Subject: RATTLE NOISE FROM HEADER PANEL OF CONVERTIBLE TOP	Bulletin No: 09-045/15
	Last Issued: 12/04/2015

2016 MX-5 vehicles with VINs lower than JM1ND*****107384 (produced before October 26, 2015)

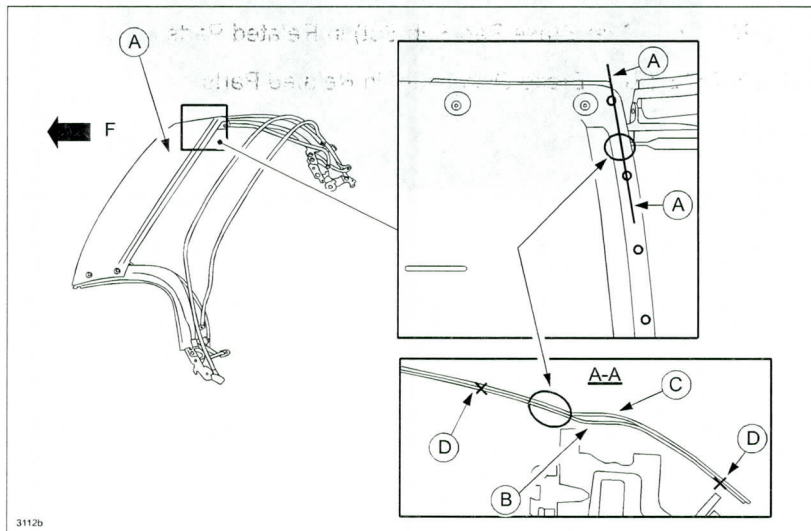
The header panel (A) is formed by two aluminum panels, inner (B) and outer (C). When receiving an input force by driving on a rough road, the two panels at the problem area, where spot welds are located (D), may warp and change relative position causing the rattling noise. (F=Front)

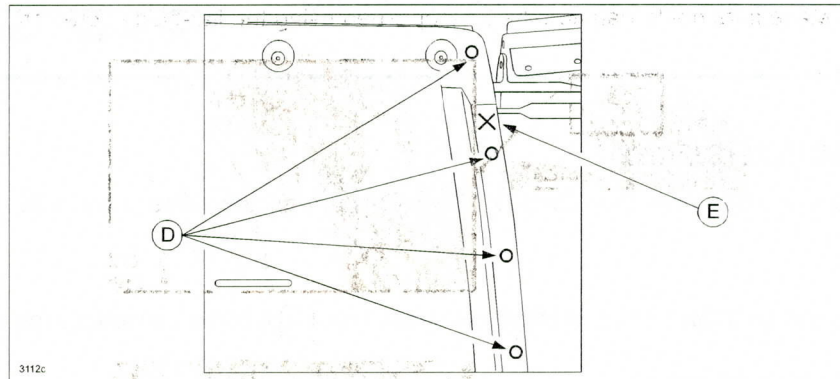
To correct the problem, a spot weld (E) has been added to the problem area, where the original spot welds are located (D), to increase the rigidity and prevent the warping.

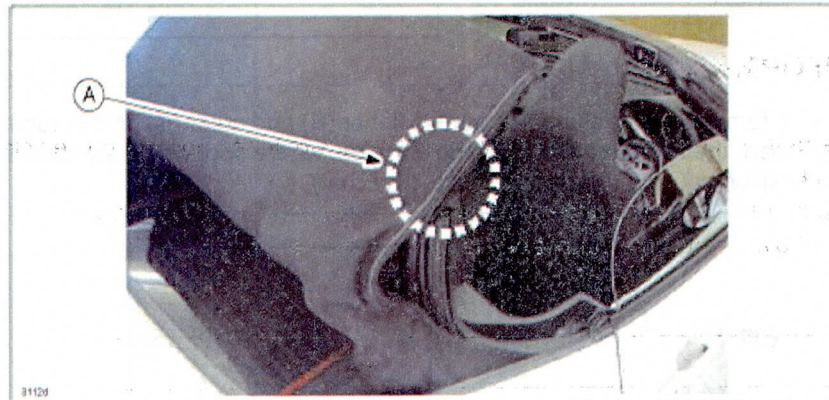
1. Verify customer concern.
2. Enlarge the gap between the inner and outer panel of the header panel at the problem area (both driver and passenger sides) using the following procedure.
 - a. Open the convertible top to a position where the area to work (A) is the most accessible as shown.

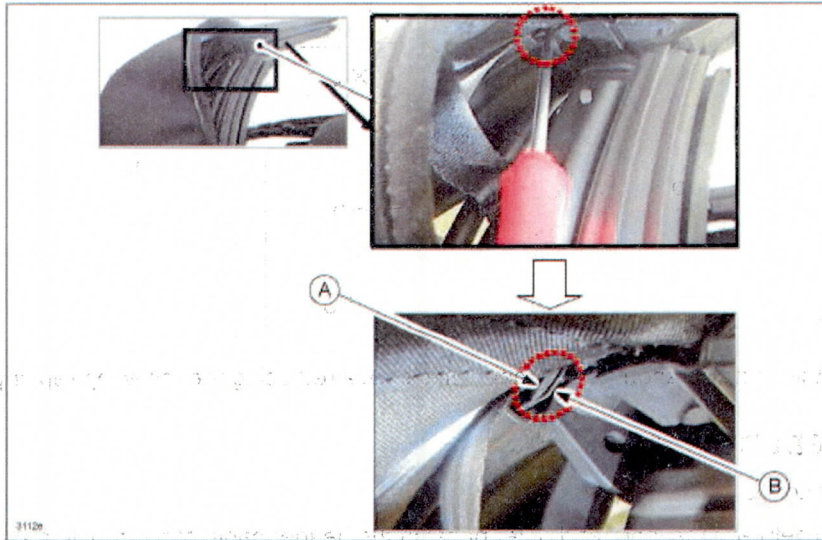
- b. Using a flat-blade screwdriver with protection tape on the tip, enlarge the gap between the outer (A) and inner (B) aluminum panel of the header panel about 1-2mm at the problem area.

CAUTION: Make sure not to damage the soft top when using the flat-blade screwdriver.
